**TOWN OF NEWBURGH
PLANNING BOARD
TECHNICAL REVIEW COMMENTS**

PROJECT NAME: CHADWICK WOODS – 5 LOT SUBDIVISION
PROJECT NO.: 19-02
PROJECT LOCATION: 174 ROUTE 300
SECTION 14, BLOCK 1, LOT 51
REVIEW DATE: 31 MARCH 2023
MEETING DATE: 6 APRIL 2023
PROJECT REPRESENTATIVE: ENGINEERING & SURVEYING PROPERTIES

CHADWICK WOODS
ROUTE 300
TOWN OF NEWBURGH
ORANGE COUNTY, NEW YORK

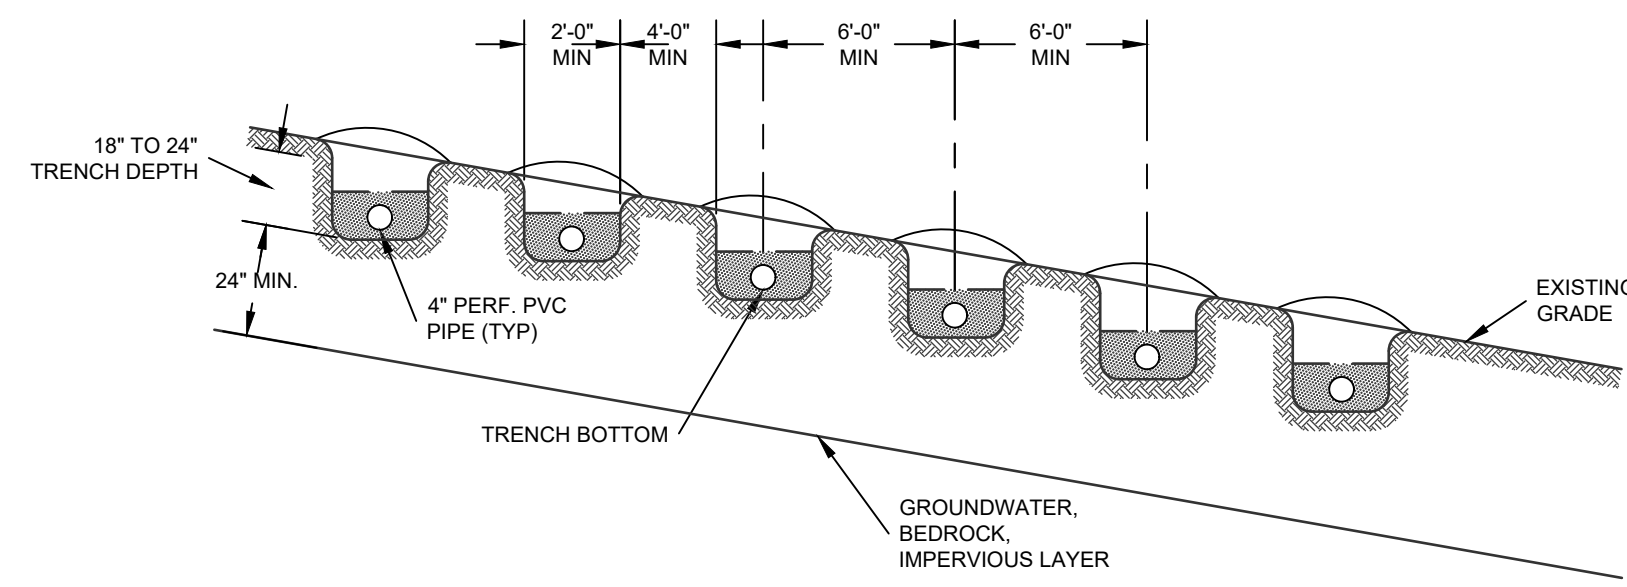
7. The sanitary sewer details conflict with the shallow absorption tile field overall plan detail on Sheet C-301 and the absorption tile field drop box details on Sheet C-302.
